Sotelo Subdivision

City of El Paso — City Plan Commission — 7/12/2018

SUSU18-00058 Major Combination

RESIDENTIAL COLLECTOR

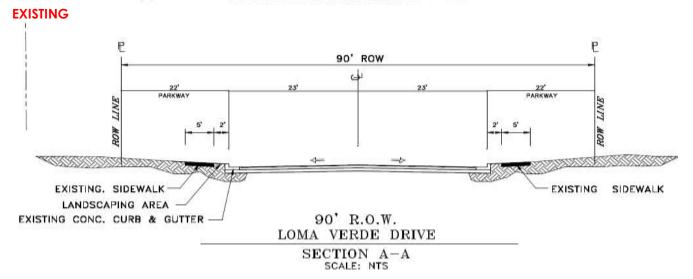
1. To waive 3' of the required 5' landscape parkway along Loma Verde Drive.

Loma Verde is classified as a residential collector requiring 56' of ROW to include 5' sidewalks, 5' landscape parkways, and 36' of pavement.

Although there is ample room to make the improvement, the applicant does meet the criteria under Section 19.10.050 (Roadway participation policies – Improvement of roads and utilities within and or abutting the subdivision) for requesting exceptions. The section reads as follows:

- 1. The City Plan Commission may waive such requirements to provide rights-of-way or street improvements to adjacent substandard roads based on any of the following factors:
 - a. Fifty per cent of the lots within a quarter mile of the proposed development have already been developed and the existing street improvements are in character with the neighborhood.
